**FIRE SERVICE LINE
 to serve
 2054 CUSTER
 LOT 1 BLK 4
 SOUTHWEST INDUSTRIAL ADD.
 CITY OF WICHITA, KANSAS**

**Gary Janzen, P.E. City Engineer
 Project Number
 1959 PPW (607853)**

AS BUILT PLANS
 Contractor: McCullough Excavation
 Inspector: Dakota Zimmerman
 Ruggles & Bohm
 PDF Made By: DGZ 03/08/2016

GARVER JOB: 4660E
 SHEET: 4R OF 10
 © Copyright 2018, Garver

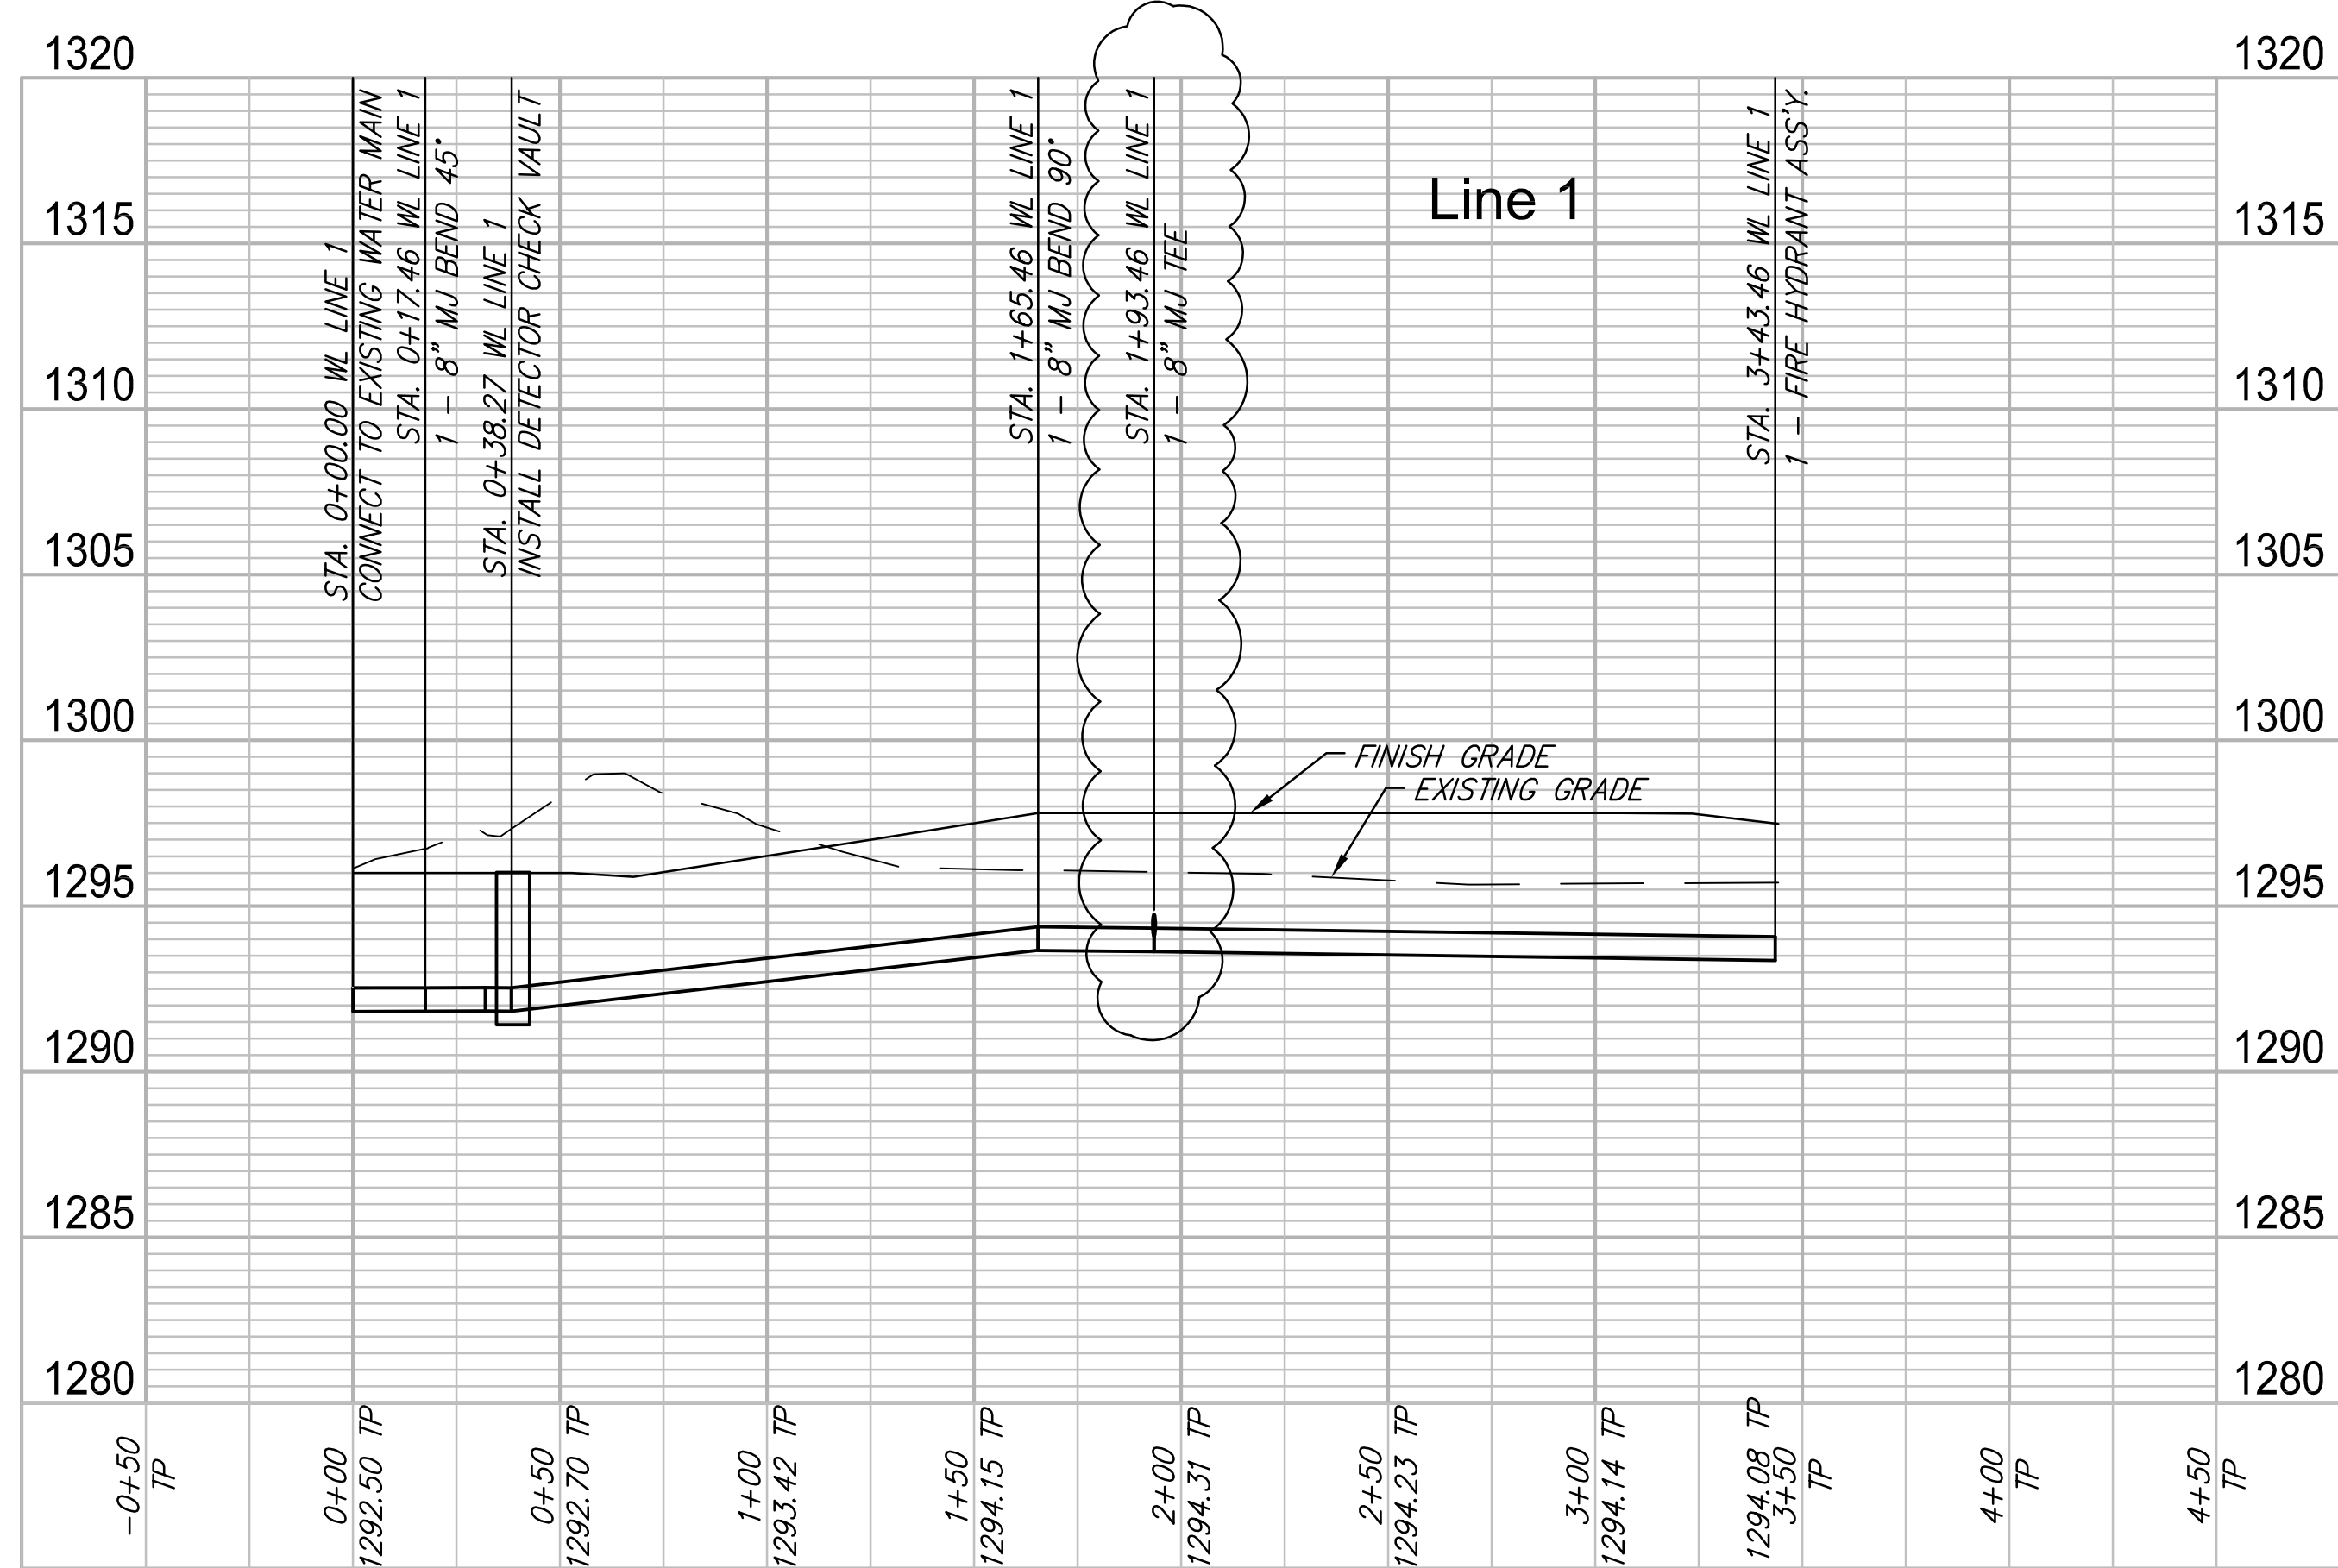
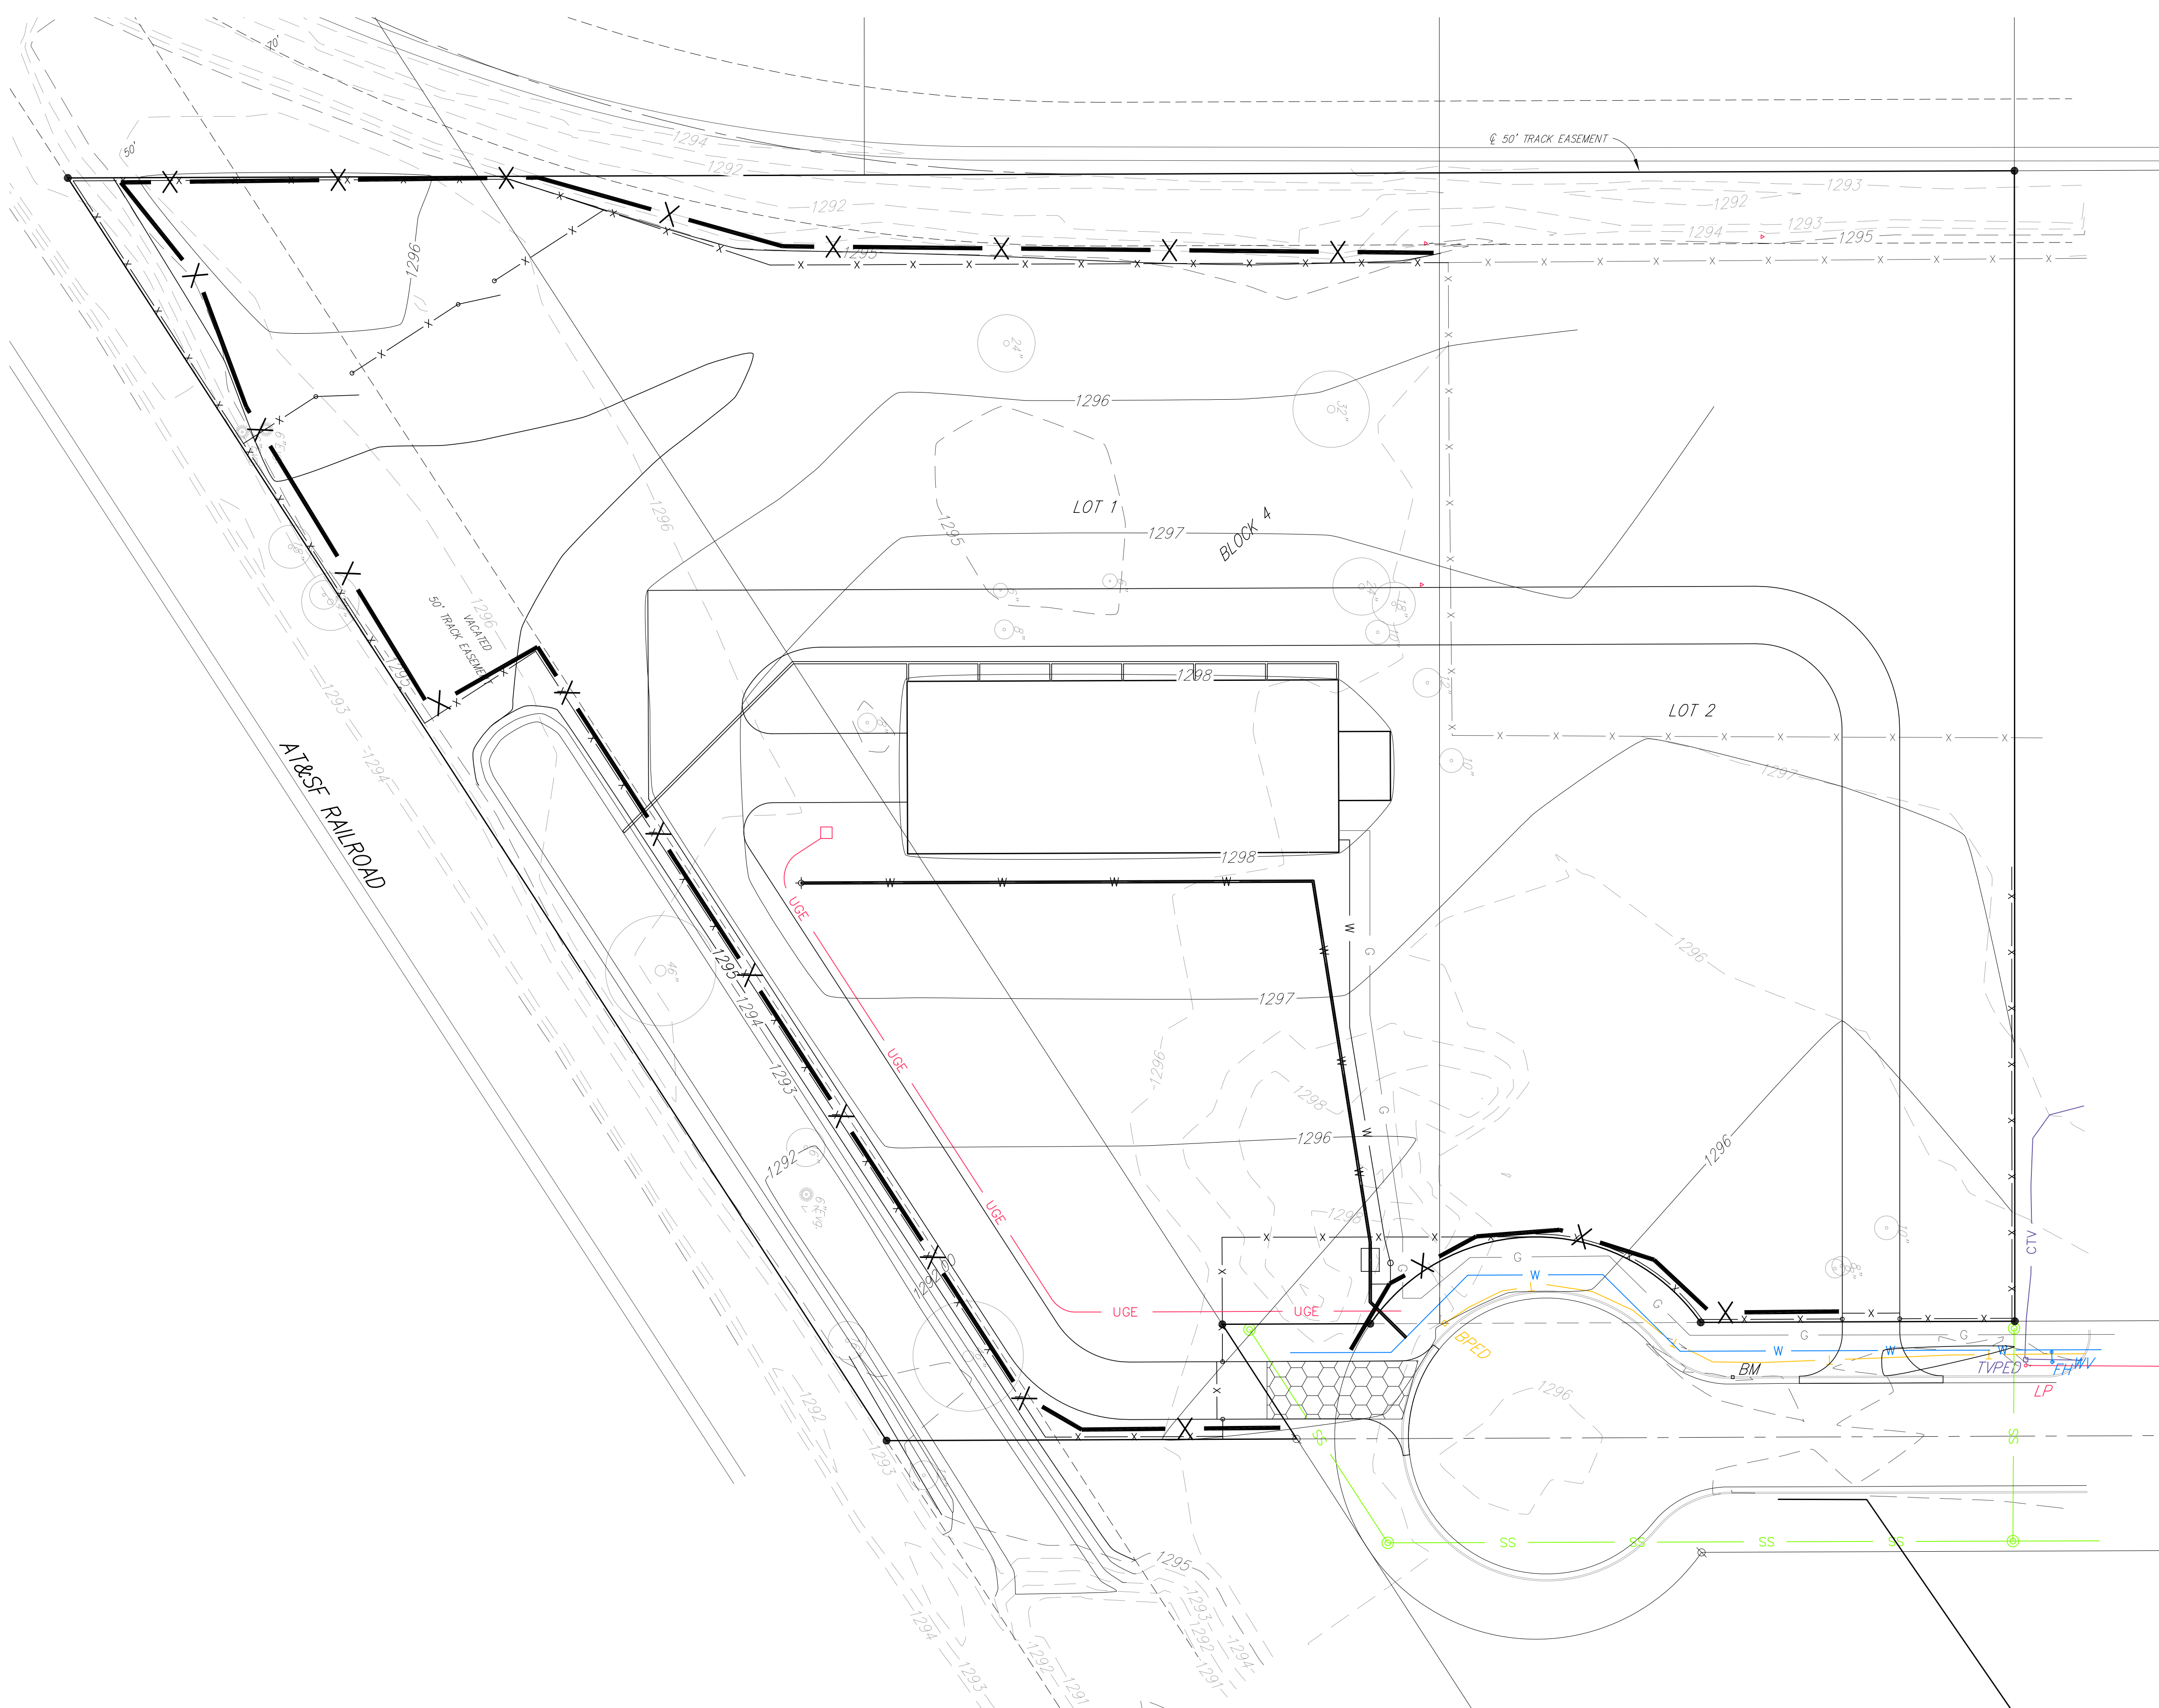
Building owner was denied
 Occupancy Permit due to no
 FDC connection. Sheet 4R
 added this connection and we
 inspected the install.
 -Dakota Zimmerman
 Garver 04/06/2018

Sheet 4R added for
 FDC
